## Change Notification I-Control usage.

With the New Sign controller firmware some great new features are added to the I-Catcher display system. This new firmware is included in systems produced after June 2020.

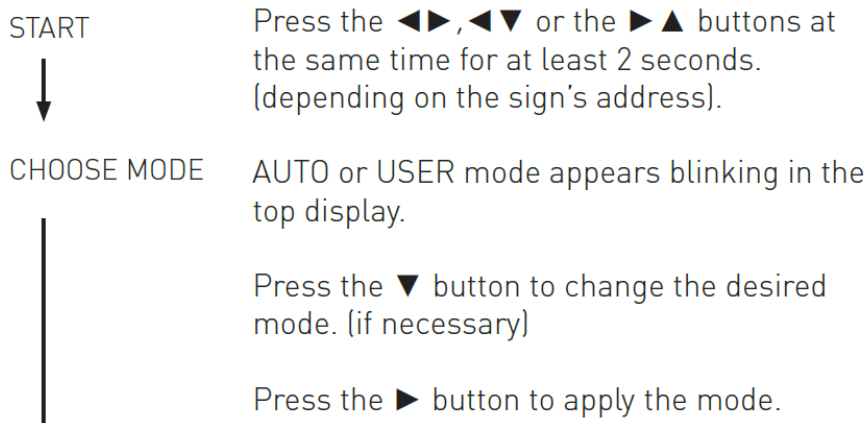
When the text AUTO or USER is shown by the top display, but doesn't blink, then you have the new firmware (v3.4.2+). This means that you need to take a new method in order to change the system mode.

- With the **new** firmware, the top display shows AUTO or USER.

- 
- With the **old** firmware, the top display starts **blinking** with AUTO or USER.
